SERVICE BULLETIN

REFERENCE ENGINE _____
NUMBER 011
DATE 10-20-89
MODEL RN

22R-E, 22R-TE HARD STARTING/ROUGH IDLE

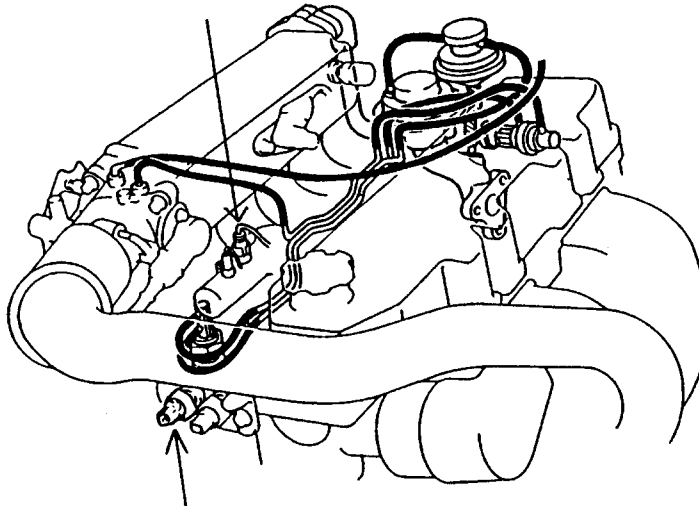
1. Replace cold start injector time switch with the new part.
2. On vehicles equipped with a pressure-up system, (see application chart on page 1) also replace Temperature Switch No. 2 with the modified one.

Switch, Temperature No. 2

Switch, Start Injector Time

HOW TO REMOVE THE WIRE TERMINAL

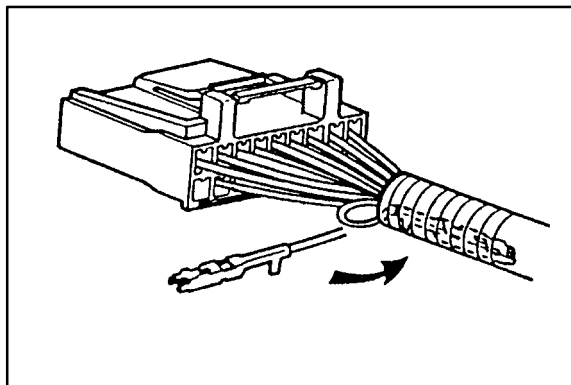
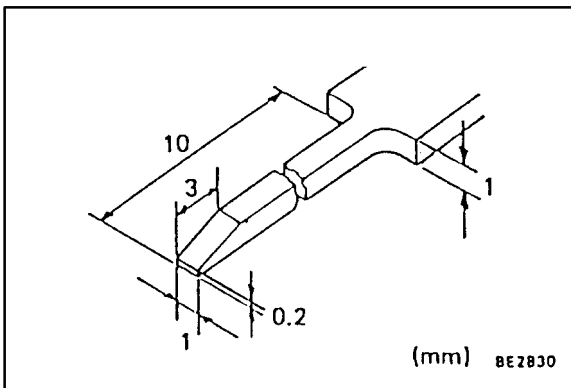
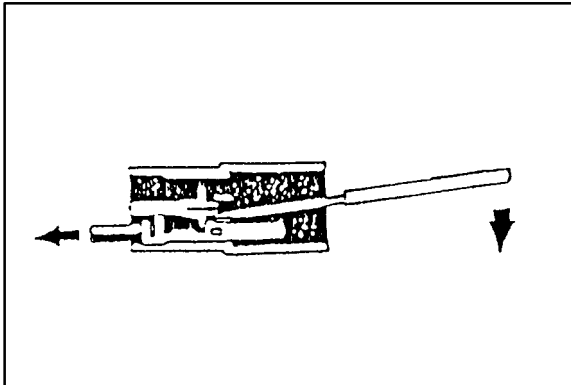
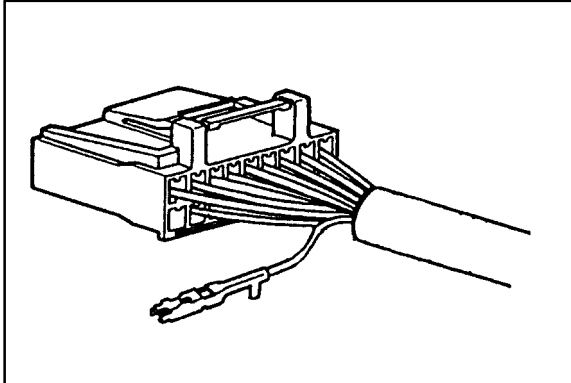
3. For vehicles equipped with Air Conditioning, the ACV terminal must be disconnected from the ECU when installing the modified Temperature Switch No. 2 (Condition 1). This is necessary to prevent the Engine Idle-Up from working continuously after warm-up.

Remove This Terminal

1. Insert a miniature screwdriver from the open end. Move the locking clip to the unlocking direction () and hold it in this position.

2. Carefully remove the terminal without using excessive force.

3. Wrap the removed wire terminal with electrical tape. Tuck the terminal into the harness protector and secure with electrical tape.
